Cyprus Plateau Mining Corporation  
P.O. Drawer PMC  
Price, Utah 84501  
(801) 637-2875

**Re: Division Letter November 11, 1992 - Requirements**

# Gentry Mountain Air Shaft

# Monitor Well 92-10-1

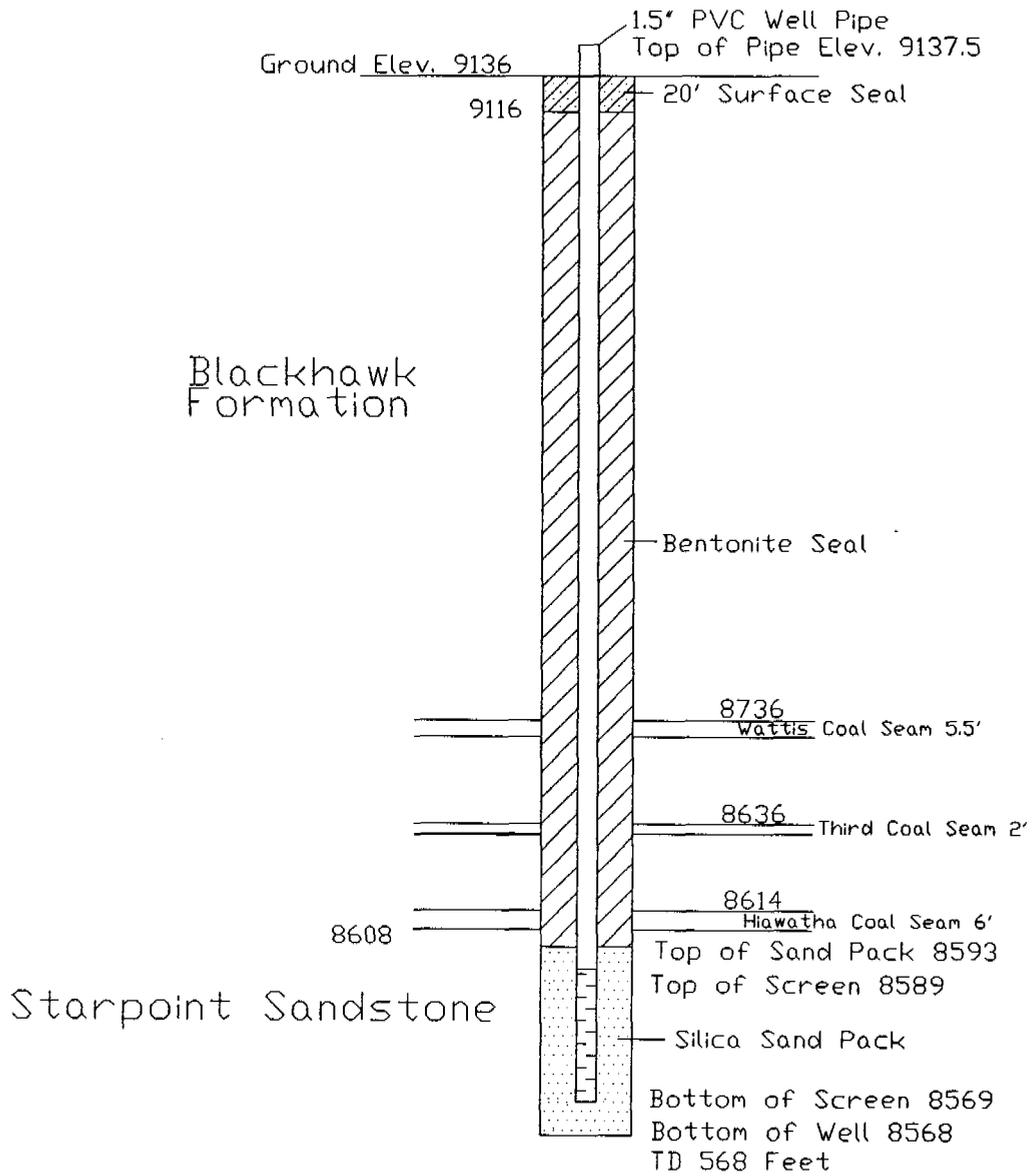
It will also be necessary to submit the finalized information (completion data) for the exploration holes.

Additionally, the BLM told the Division that one of the holes was converted to a water monitoring hole, which the Division was not aware of until that time. The location of this hole, the completion records, and what information will be gathered from this hole, which the Division assumes will be for baseline information, must be submitted to the Division by December 11, 1992, to update the PHC document.

Only one exploration hole was completed during 1992, hole PP10-1. This hole is the one selected for installation of a ground water monitoring well (No. 92-10-1) as discussed with Tom Munson, and Ken Wyatt on September 1, 1992 in the Division's office, and as shown on Map 728b as a potential in-mine well located in Little Park Canyon. During the September 1 meeting, we discussed this location for either a surface well or an in-mine well. The enclosed Monitor Well 92-10-1 schematic shows details of the strata as well as the monitor well.

David Hansen of Hansen, Allen and Luce and I discussed this well and it's location with Tom and Ken on September 1, 1992. The approximate location was shown on Map 728b (within the 600' square) which was a part of the PHC revision. The actual location is shown on the enclosed copies of Map 728b (within the square). Due to ongoing geologic work, the exact location of the exploration hole/well had to be selected at the last minute.

The enclosed well schematic shows details of the well completion. The well was permitted through the State Engineer's office (approval attached).

We believe it is not necessary to include in the PHC or the permit details of monitoring well designs since the construction is regulated by the State Engineer and the wells have to be certified by a certified well driller as per State standards. Our installations have been and will continue to be in compliance with state standards. Well construction will be similar to the design of well 92-10-1 (copy enclosed).
